**Work Order ID 97433****\*97433\***

Item Name: Crosstube Aft

**D407-667-245 MACHINING DETAIL**

DRAWING NO. D407-667-245	TITLE CROSSTUBE ASSY (407 HIGH AFT)	REV. F	DART AEROSPACE LTD ENGINEERING ORDER		D.E.O. NO. D407-667-245-F-1	SHEET NO. SHEET 1 OF 2	SCALE NTS
DRAWN <i>h</i>	CHECKED <i>q</i>	MFG. APPR. <i>E</i>	APPROVED <i>h</i>	DE APPR. <i>h</i>			
DATE 11.04.08	DATE 11.04.12	DATE 11.04.12	DATE 11.04.12	DATE 11.04.12

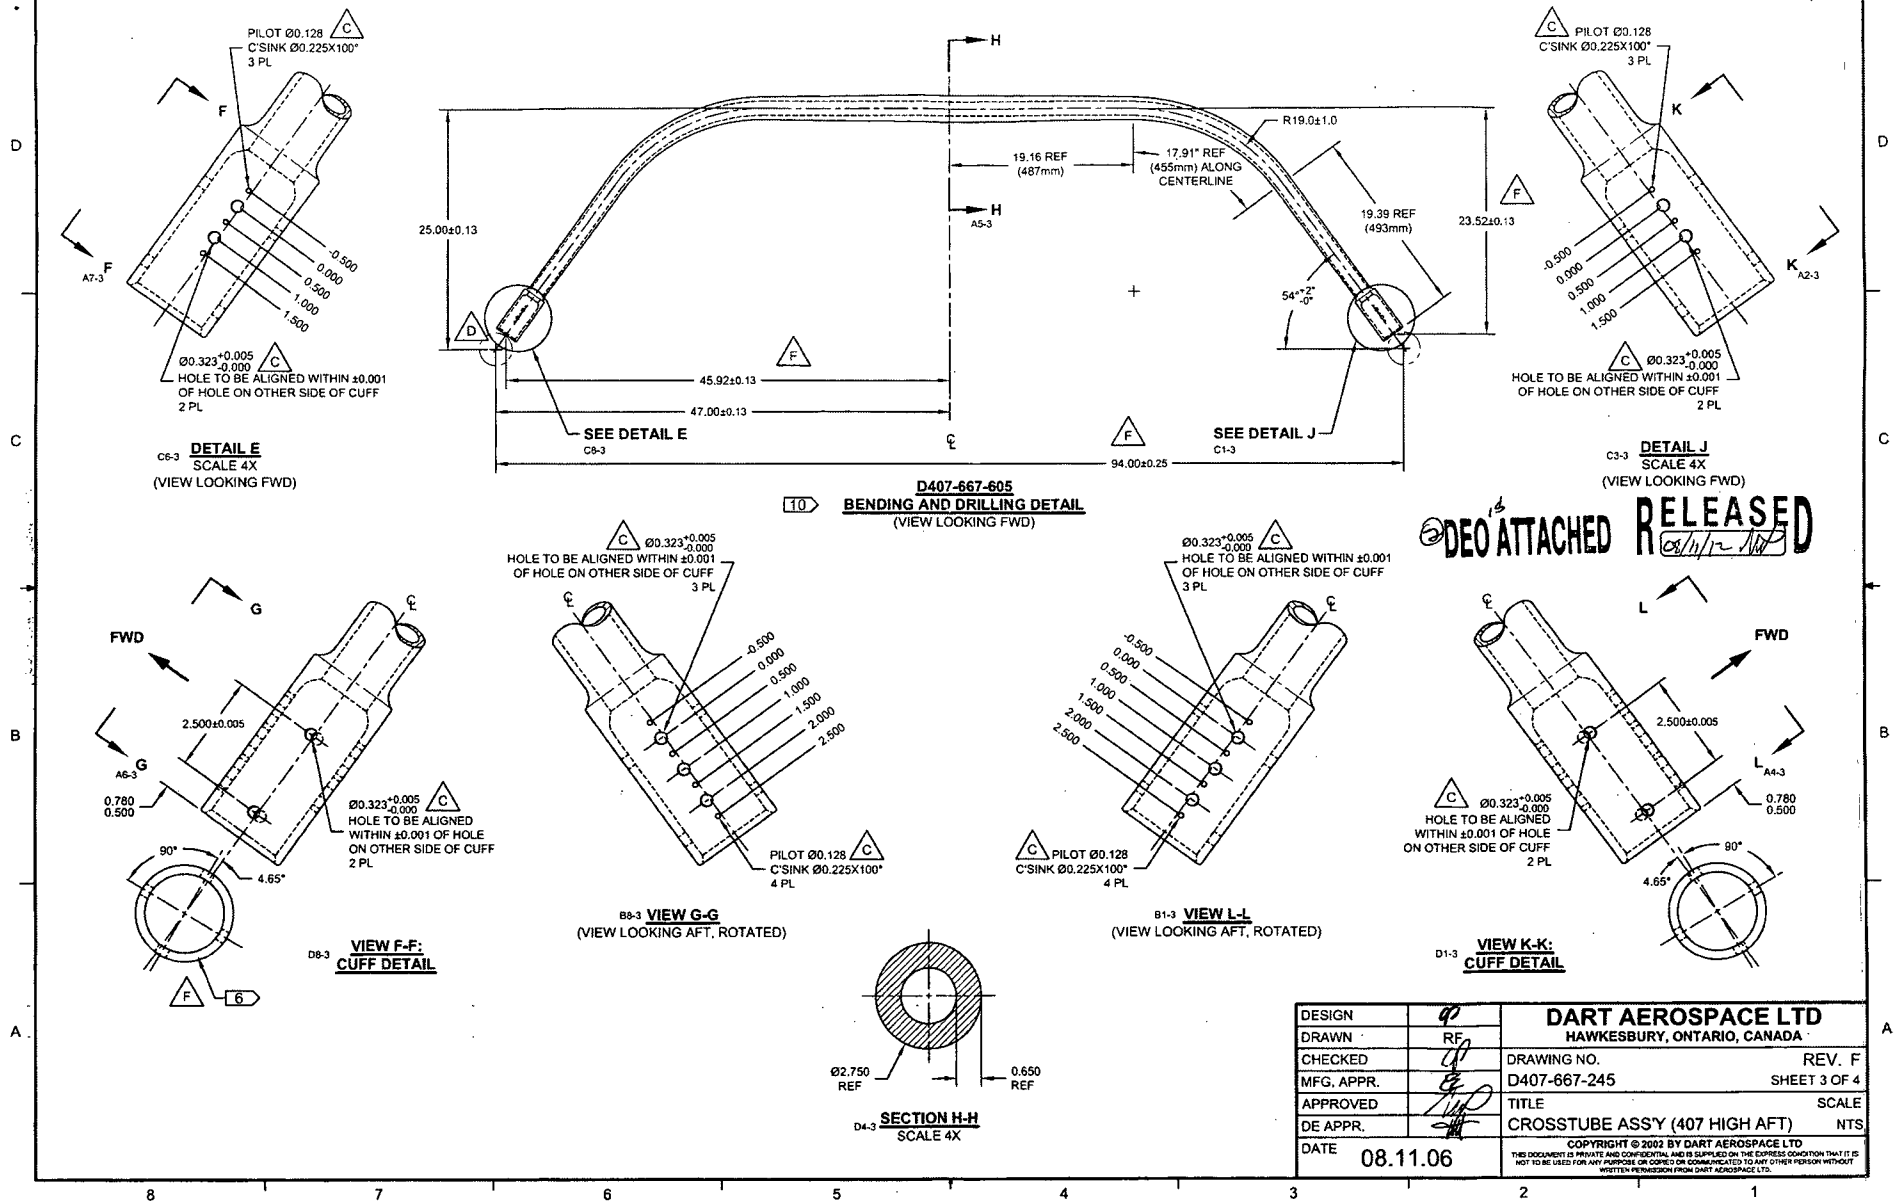
F	REFORMAT NOTES TO NEW STANDARDS (ZN B8-1); RELOCATED FLAG # 6 (ZN A8-3) PER NCR 210; REMOVED REF. & ADD TOLERANCES (ZN C6-3, C4-3 & D2-3)	RF	08.11.06
E	8.02 AND 8.53 WERE 8.40 AND 8.90 (ZN D5-2); REORGANIZED VIEWS AND REFORMATED DRAWING TO CURRENT STANDARDS. REASONS: CLAMPS MOVED 0.375 TOWARD CL TO ELIMINATE INTERFERENCE WITH AIRCRAFT MOUNTS. REFERENCE: FAR#08-21 AND ECR#1225	MB	08.07.24
D	ADD VIEW FOR OEM SKID HOLES, ROTATE ORIENTATION OF CLAMPS SECTION F-F, REMOVE -851 ABRASION STRIP, ADD MAGNOBOND 6398, ADD CUSHION	PH	07.02.07
C	ADD HOLES AND NUT PLATES FOR COMPATIBILITY WITH BHT/AA SKIDTUBES	PH	05.07.26
B	ADD CHAFING SHIELD	CP	03.05.21
A	NEW ISSUE	CP	02.05.13
REV.	DESCRIPTION	BY	DATE
DESIGN	RF	<b>DART AEROSPACE LTD</b> HAWKESBURY, ONTARIO, CANADA DRAWING NO. D407-667-245 REV. F SHEET 1 OF 4 TITLE CROSSTUBE ASSY (407 HIGH AFT) SCALE NTS COPYRIGHT © 2002 BY DART AEROSPACE LTD THIS DOCUMENT IS PRIVATE AND CONFIDENTIAL AND IS SUPPLIED ON THE EXPRESS CONDITION THAT IT IS NOT TO BE USED FOR ANY PURPOSE OR COMMUNICATED TO ANY OTHER PERSON WITHOUT WRITTEN PERMISSION FROM DART AEROSPACE LTD.

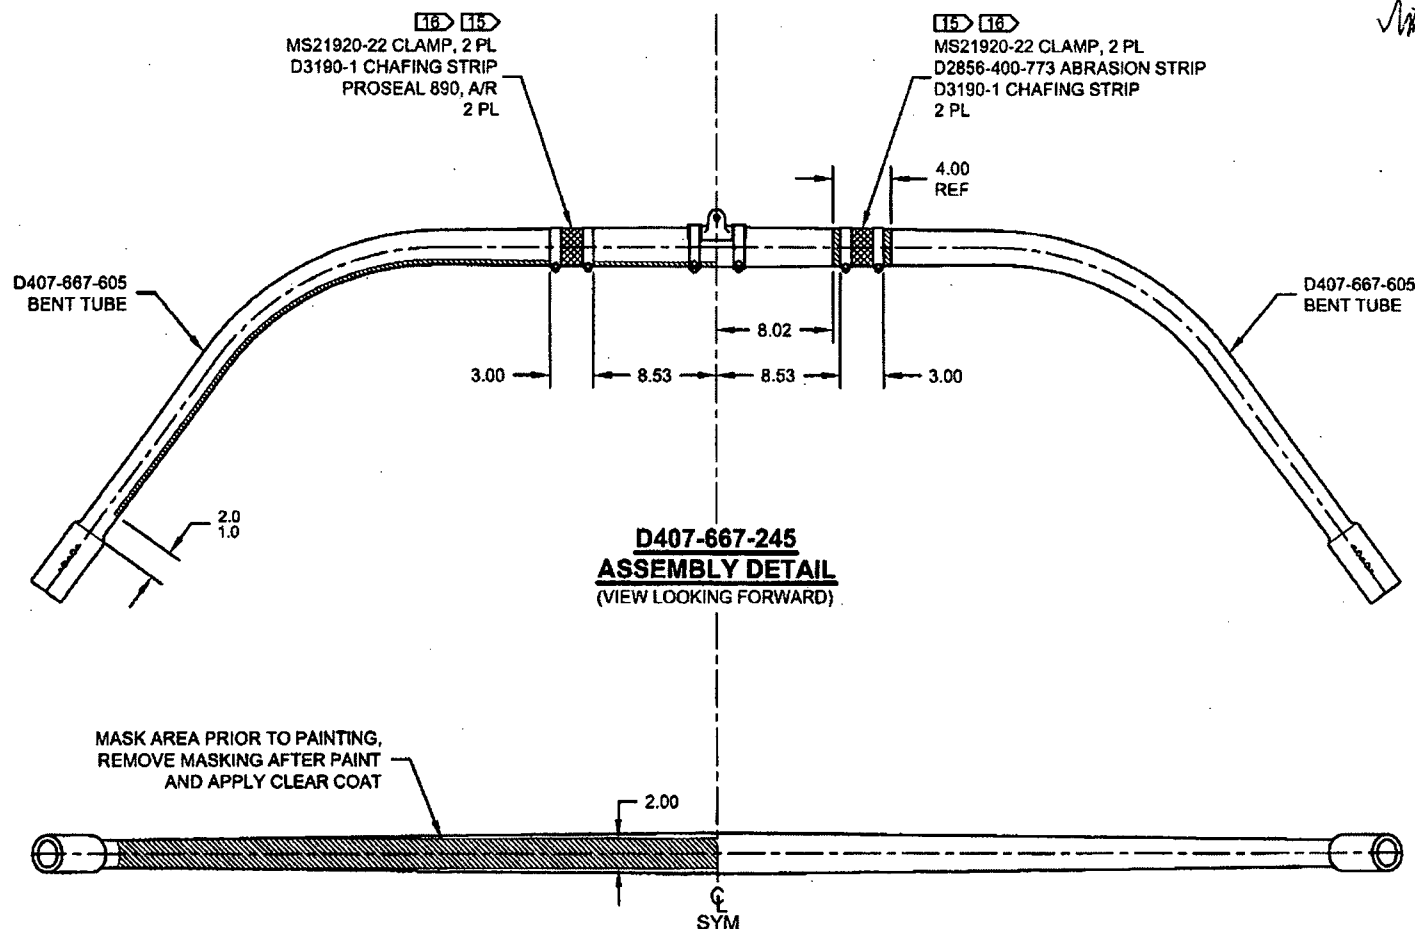
**CHANGE:**

NOTES 2 AND 15, SHEET 1 ARE AMENDED AS FOLLOWS:

- 2) FINISH: CHEMICAL CONVERSION COAT PER DART QSI 005 4.1  
PRIME INSIDE AND OUTSIDE PER DART QSI 005 4.2  
MASK UNDERSIDE OF CROSSTUBE AS SHOWN (HATCHED AREA) AND  
PAINT OUTSIDE PER DART QSI 005 4.2  
REMOVE MASKING AND APPLY CLEAR COAT
- 15) APPLY A THIN COAT OF PROSEAL 890 ON INSIDE CONCAVE SURFACE OF D3190-1  
CHAFING SHIELDS AND LET CURE PER MANUFACTURER'S INSTRUCTIONS. INSTALL  
PROSEALED D3190-1 CHAFING SHIELDS ONTO CROSSTUBE BY APPLYING A THIN COAT  
OF PROSEAL 890 ONTO CROSSTUBE. BE SURE TO ELIMINATE ANY AIR GAPS.

- 2) FINISH: CHEMICAL CONVERSION COAT PER DART QSI 005 4.1  
PRIME INSIDE AND OUTSIDE PER DART QSI 005 4.2  
PAINT OUTSIDE PER DART QSI 005 4.2
- 15) INSTALL D2856-400-773 ABRASION STRIP WITH A 0.13 REF GAP ON BOTTOM SIDE OF  
CROSSTUBE PER QSI 035.
